**CONWAY**  
HISTORIC DISTRICT COMMISSION  
**MAY**

# 1. MRK Properties Carport Addition

## ROBINSON HISTORIC DISTRICT CERTIFICATE OF APPROPRIATENESS REVIEW

Address: 937 Center Street

Applicant Provided Sketch of Proposed Carport

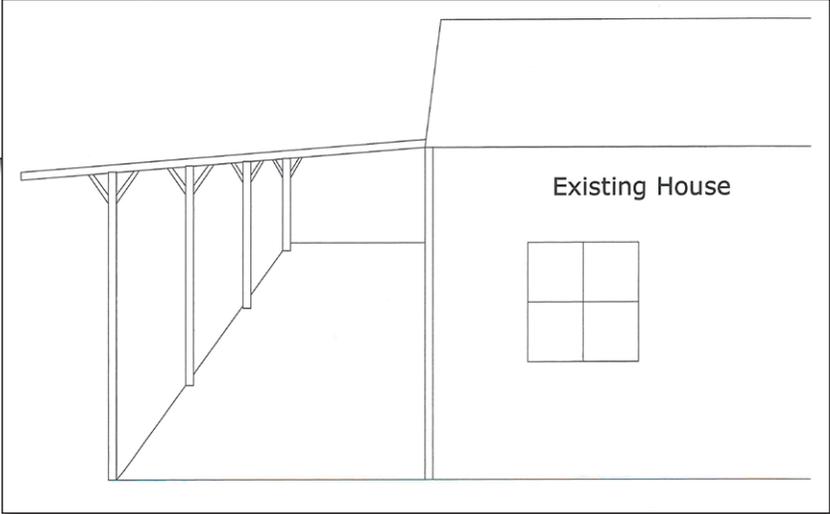
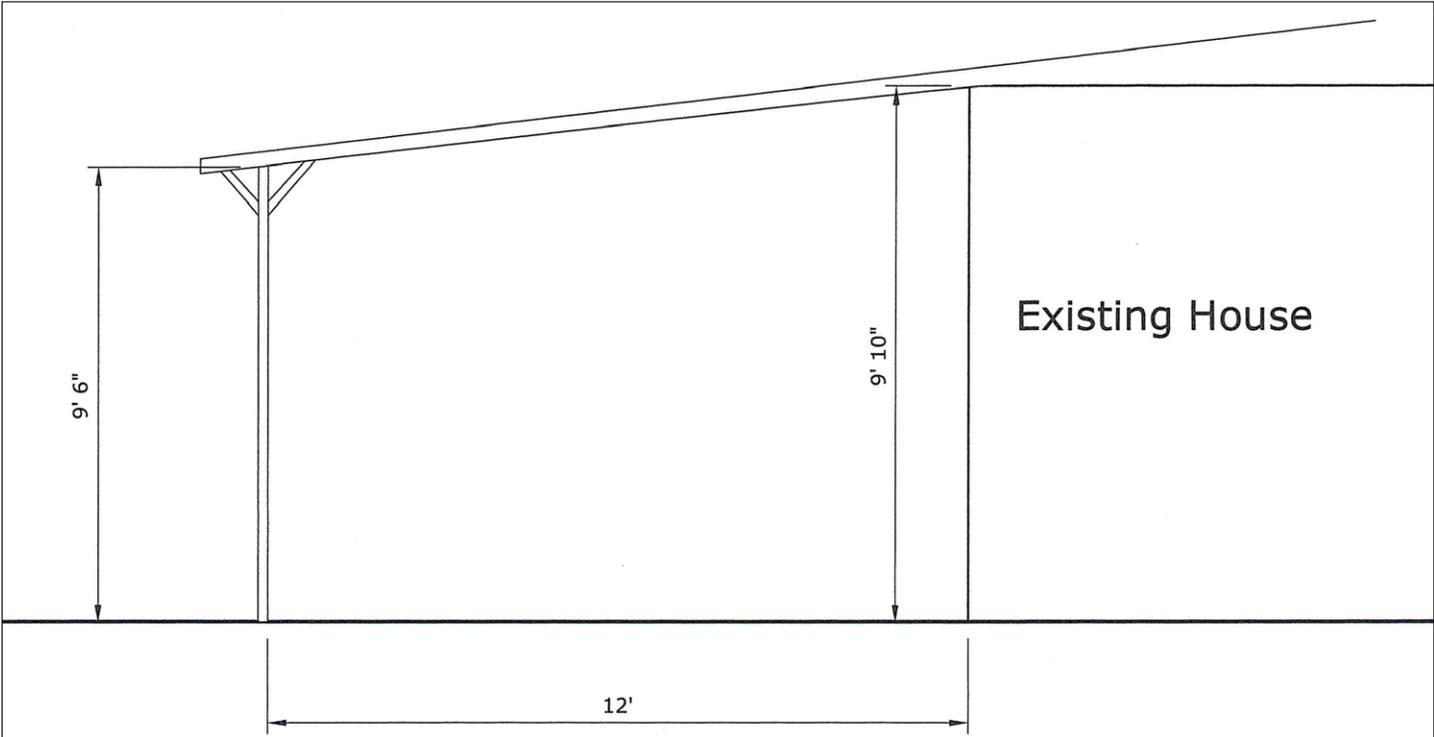
**Setbacks:** Proposed structures should respect the predominant setbacks of area structures, especially the front setback. The proposed carport's roof line would be approximately 5 feet or less from the south property line. There is an existing garage/carport on the property line on the neighbor's lot to the south.

**Spacing:** Established spacing distance pattern between area structures. It is common for accessory structures to be adjacent to or on the property lines with little or no setback in the Robinson District and the Old Conway area. However, the proposed spacing would place two carports in close proximity to each other.

**Tree preservation:** There are a couple of silver maple trees along the shared property line. These trees could be affected by this project. The applicant can provide more details at the HDC meeting.

**Width.** New construction proportions shall respect the average widths of the majority of neighboring buildings in the area. The proposed carport width should be examined to determine the affect on the neighboring property.

The proposed carport is utilitarian in function and style. The proposed location would be largely hidden from the public view along Center Street. The design is a simple lean-to style roof sloping to the south.

The largest concern with this project is roof water run off. As proposed, the roof drip line would be 5 feet or less from the property line. There is an existing covered carport and garage on the adjoining neighbor's lot to the south built on the property line. Water from both roofs could potentially accumulate near the same drip line causing ponding. The proposed roof slope could be changed towards the rear, gutter(s) could be added, the width slightly decreased, or some combination. The applicant can give more details concerning setbacks and drainage at the HDC meeting.

1. The carport shall be constructed as shown on submitted plans (or modified as necessary per HDC review).
2. Roof shall be asphalt composition to match existing home.
3. Carport trim shall be painted to match the existing home.
